Interactive comment on “Are streamflow recession characteristics really characteristic?” **by M. Stoelzle et al.**

M. Stoelzle et al.

Referee: This manuscript compares the results obtained from recession curve fitting for different (a) selection criteria for recession periods and (b) curve-fitting methods for the selected recessions. The findings are interesting, but the presentation could be improved in several ways.

Fig. 1. Relative frequency of slope b for different extraction procedures (VOG, KIR, BRU) and different model fittings (REG, LE, BIN).

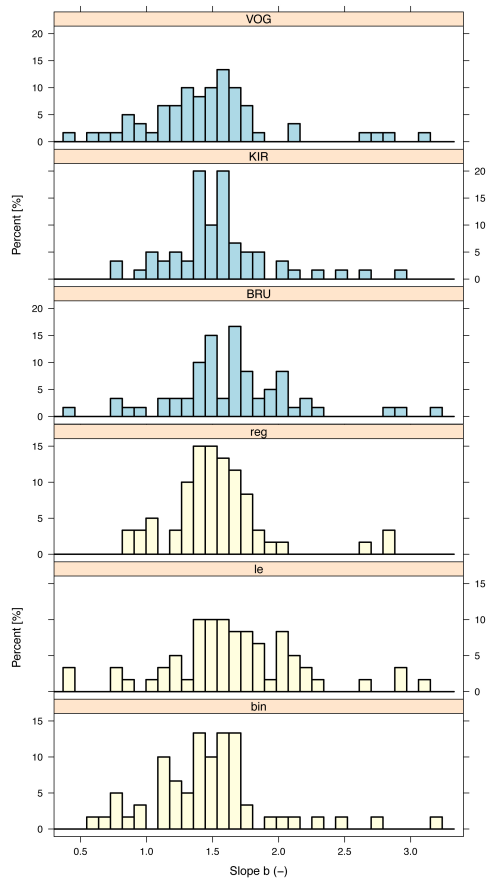
2) Along the same lines, the different methods were devised under different theoretical assumptions and largely for different purposes. It probably is not fully correct to say that the differences found between methods "elucidate a considerable uncertainty", since these differences are not some quasi-random scatter; rather, depending on the application, one of the methods may well be the most appropriate one to use to estimate a recession curve, while others are inappropriate.

quence the mentioned paragraph in the conclusion could be rephrased (page 10583, line 26 – page 10584, line 2): "We suggest that the limited comparability of recession characteristics derived with different RAMs elucidate the distinctiveness of individual analysis methods. . ." However, the attached distributions of slope b (Fig.1) indicate that neither the extraction methods nor the fitting models lead to distinguishable estimations of parameter b . As all methods have strength and weakness and as the real recession parameterization is unknown it seems to be problematic to find one, single adequate RAM for a certain application. For example, a lower envelope (LE) provides a much wider distribution of estimated slopes b compared to the linear regression fitting model (REG). This suggests that, for example, a estimation of spontaneous groundwater outflow with LE-model might lead to a much higher slope b than the other fitting models REG and BIN (for the same catchments), thus to faster receding streamflow recessions, even though the lower envelope should represent the lowest decline in a dQ/dt - Q -plot for a certain value of Q . This hampers the choice of the best method for a certain application as the bias of one method seems to be too large to distinguish the different parameter estimations.
